STAFF RECOMMENDATION
1404 North 14th Street
November 19, 2018

Application: New Construction - Addition
District: Eastwood Neighborhood Conservation Zoning Overlay
Council District: 06
Map and Parcel Number: 07214017500
Applicant: Daniel Reeder
Project Lead: paul.hoffman@nashville.gov

Description of Project: Revision to previously-approved rear addition and alteration to existing window dimensions. The permitted addition was seven inches (7") taller than the ridge of the house; the proposed addition is two feet (2') taller than the ridge of the house.

Figure 1. 1404 North 14th Street, rehab and addition in progress

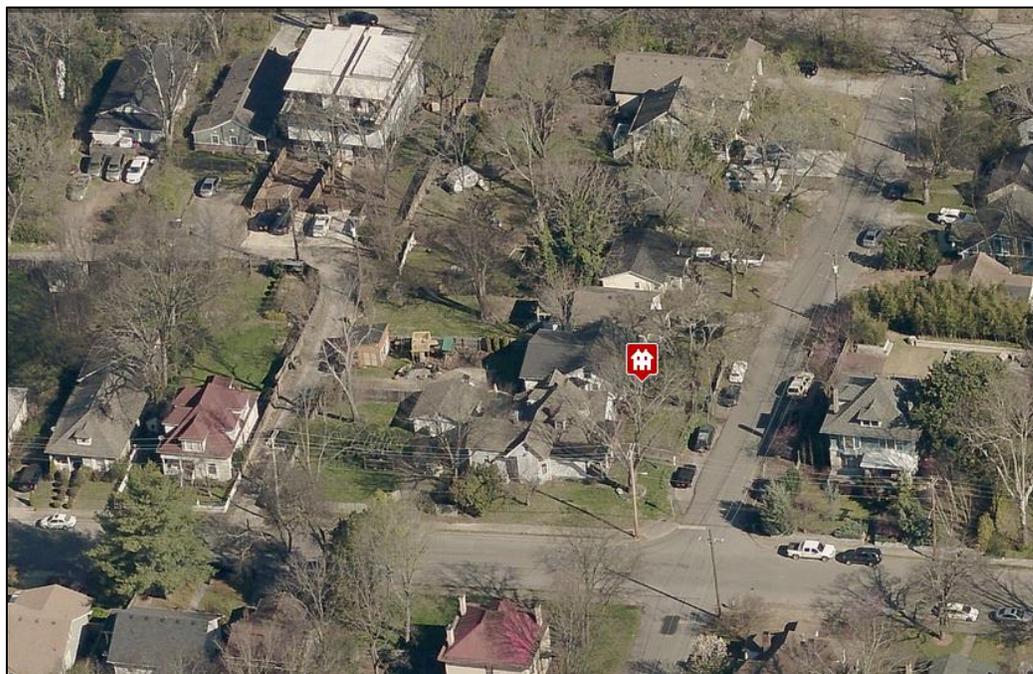
Background: 1404 North Fourteenth Street dates to 1930 and is a contributing building in the Eastwood Neighborhood Conservation Zoning Overlay. In December 2017 the Commission approved a rear addition seven inches (7”) taller than the existing ridge. The addition is in progress, awaiting approval of this application to resume.

Figure 3. Existing window openings on left elevation proposed to be resized.

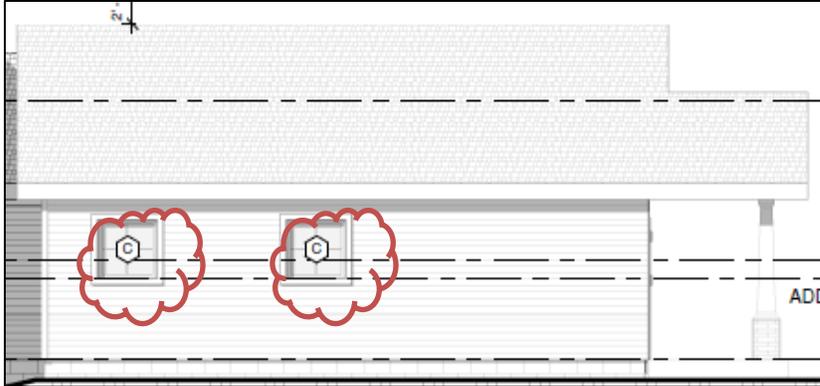
Partial Demolition: The submitted drawings indicate that two of the existing window openings on the left side of the house are proposed to be resized to square windows. As this is toward the rear of the house, and a difficult location to see from the street, Staff finds that the proposed alteration meets Section III.B.2 for demolition.

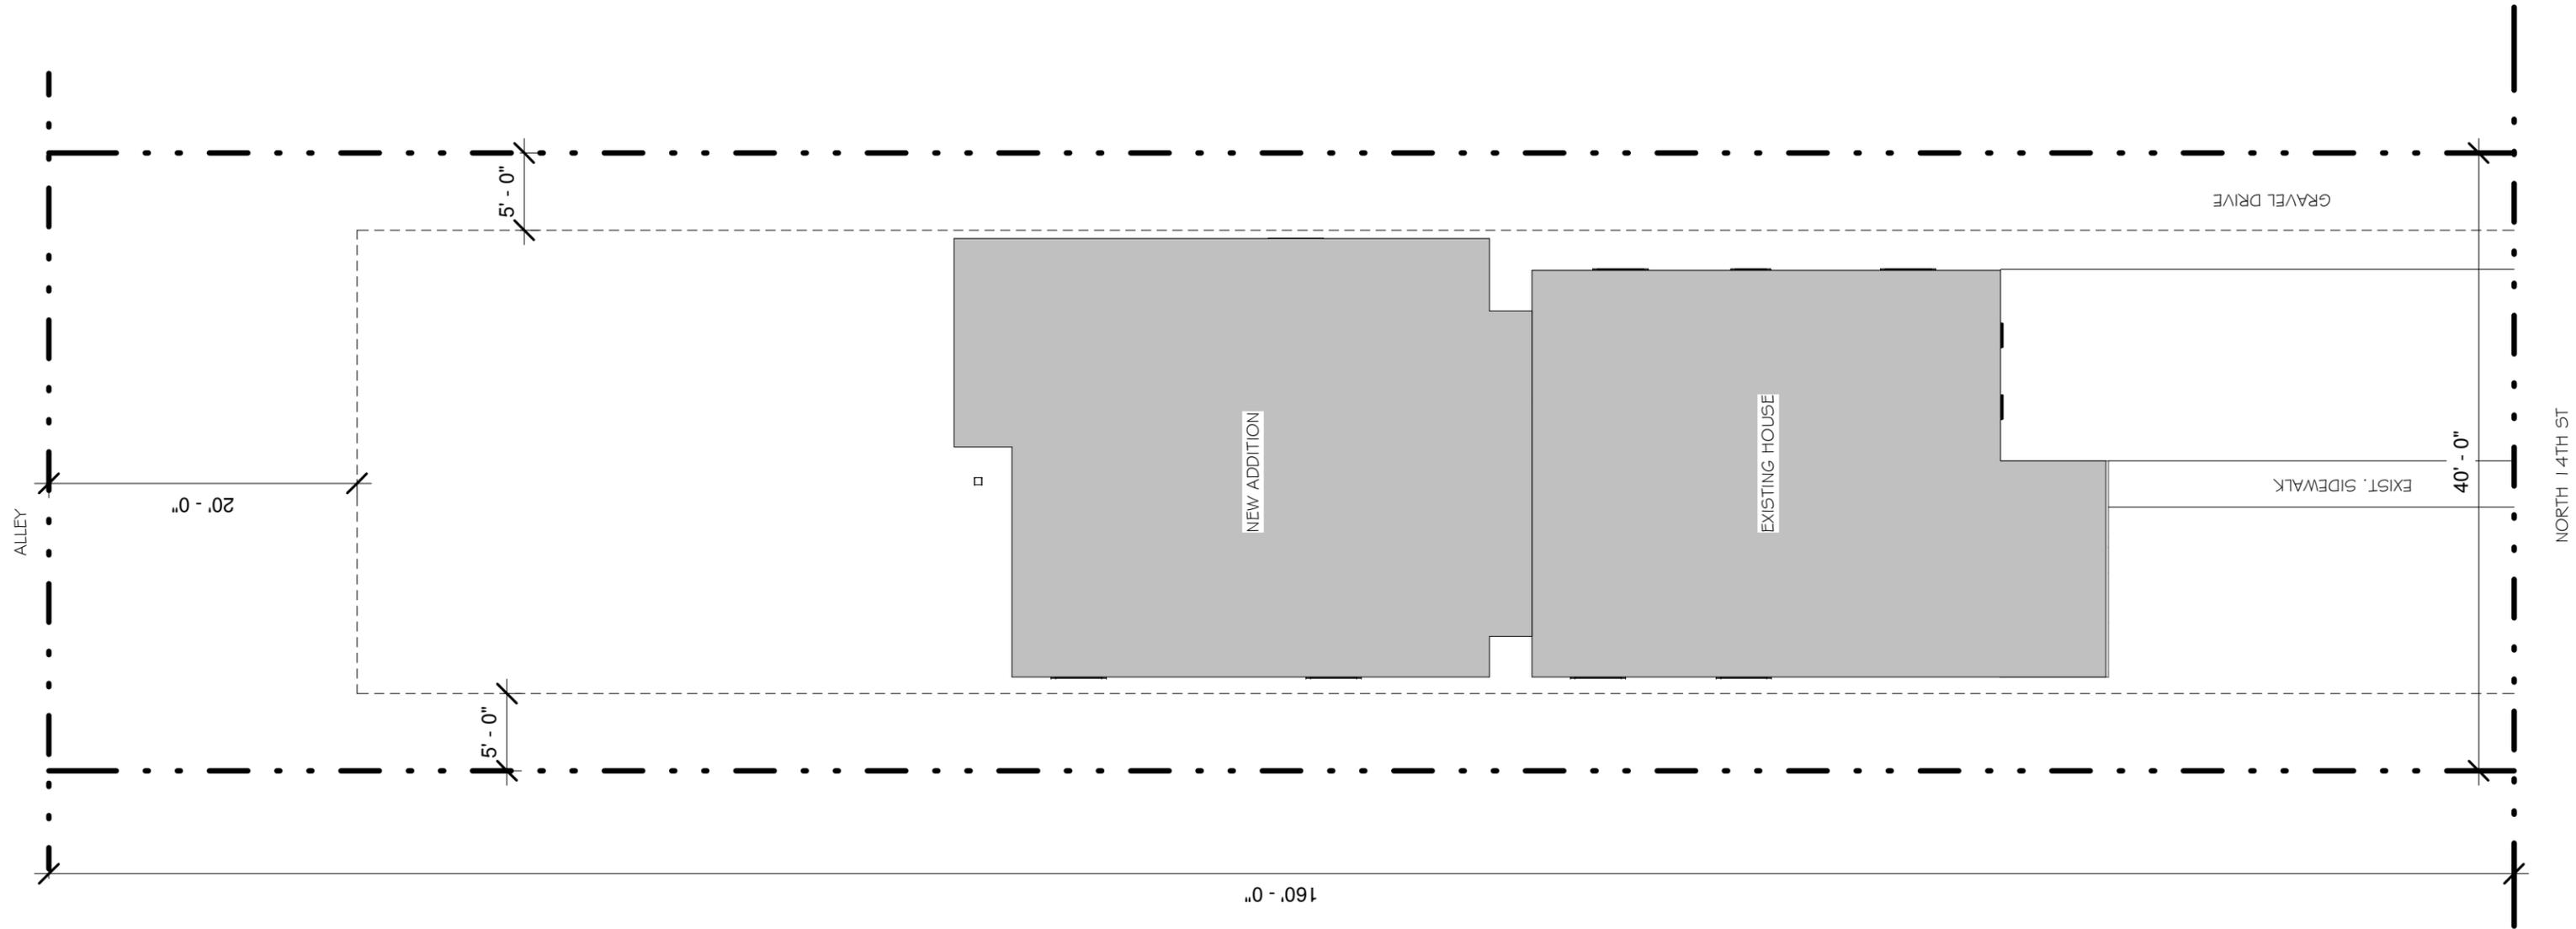
The addition’s eave height will match that of the historic house at approximately nine feet (9’) from grade, which is appropriate. The addition will have a maximum height of two feet (2’) taller than the ridge height of the house, at a distance of thirty-three feet (33’) from the front wall of the house. The design guidelines allow for additions to go taller than the historic house, typically at a distance of forty feet (40’) or more from the front of the house when necessary. As the existing building is small, at twenty-eight feet (28’) wide, and seventeen feet (17’) in height, and the front-facing gable is a difficult form for concealing an addition, Staff finds that the added height and proposed distance of just thirty-three (33’) feet is appropriate in this instance. Because of the minimal additional height, and with the clipped roof facing the front, the addition will not be highly visible from the street.

Roof form: The addition has a clipped roof facing the front and a gable at the rear. The pitch is 7.5/12. Each side of the addition was approved with a ten-foot (10') wide dormer. With the additional roof height, the dormers have been moved off the addition's ridge by two feet (2'). The proposed roof form is compatible, and the project meets section II.B.1.e.

SITE PLAN

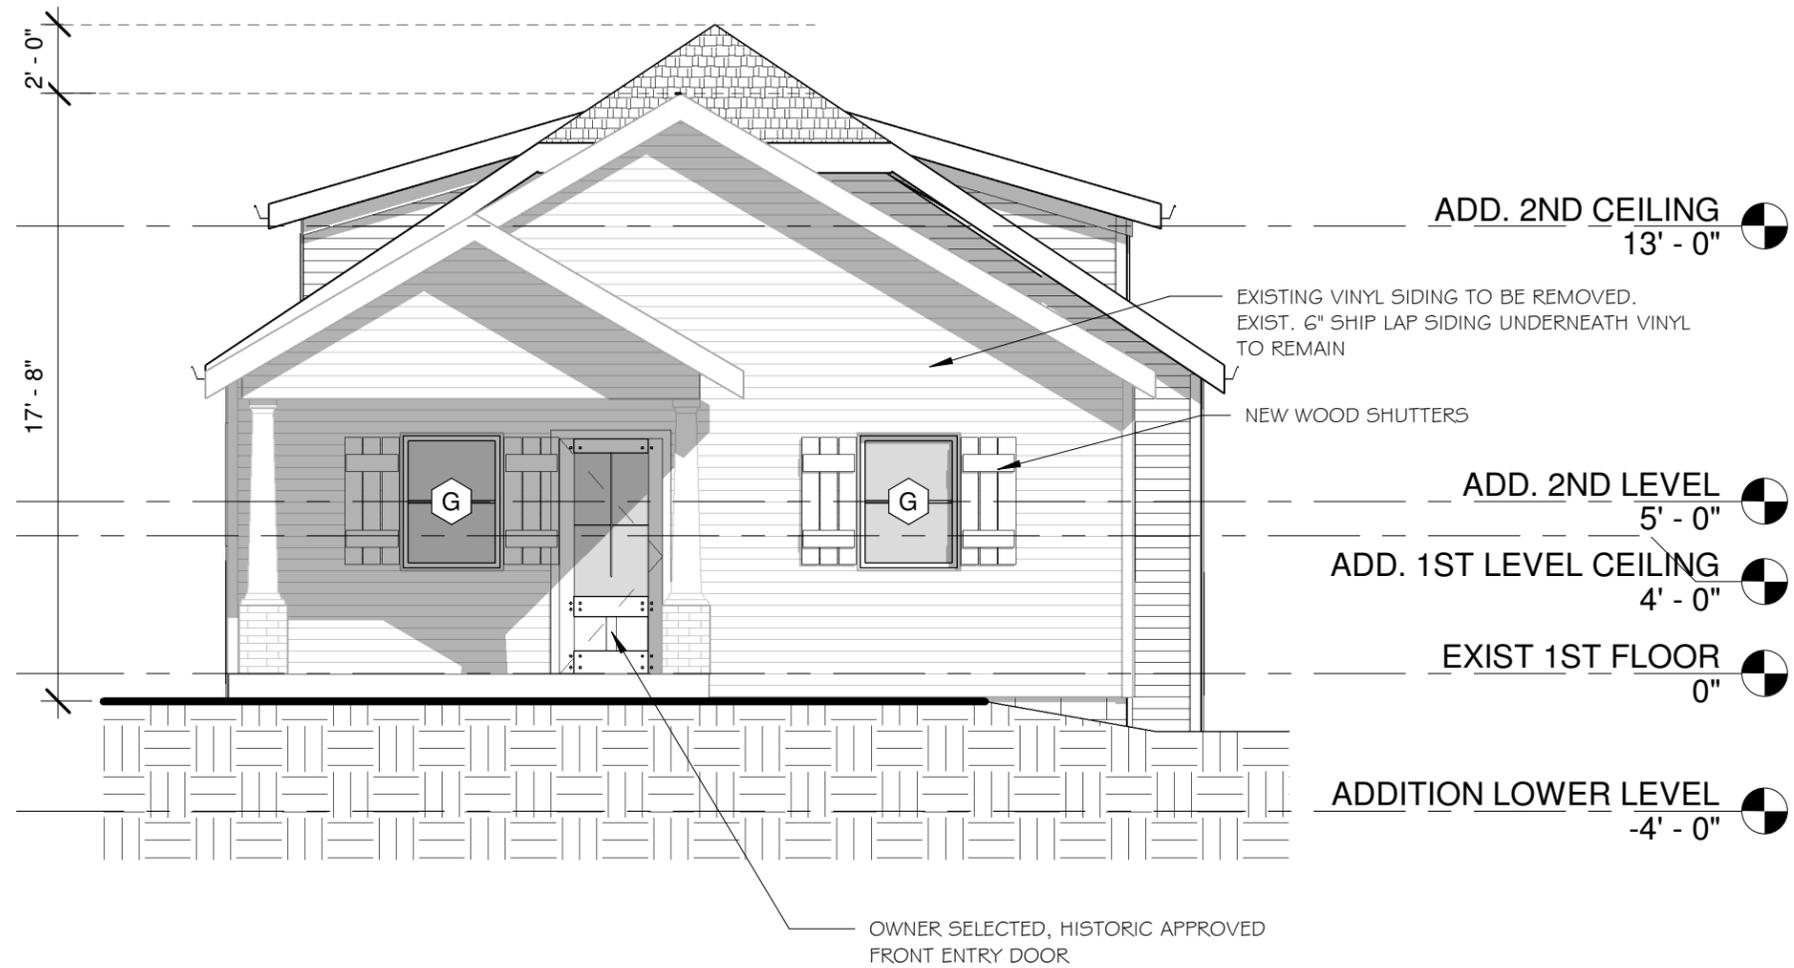
Setback: The footprint and setbacks have not changed from the previous submittal. The rear wall of the addition will be fifty-nine feet (59’) from the rear property line. The left and right side setbacks will be six feet (6’) and five feet (5’) respectively. The new construction meets base zoning setbacks. The project meets section II.B.1.c.
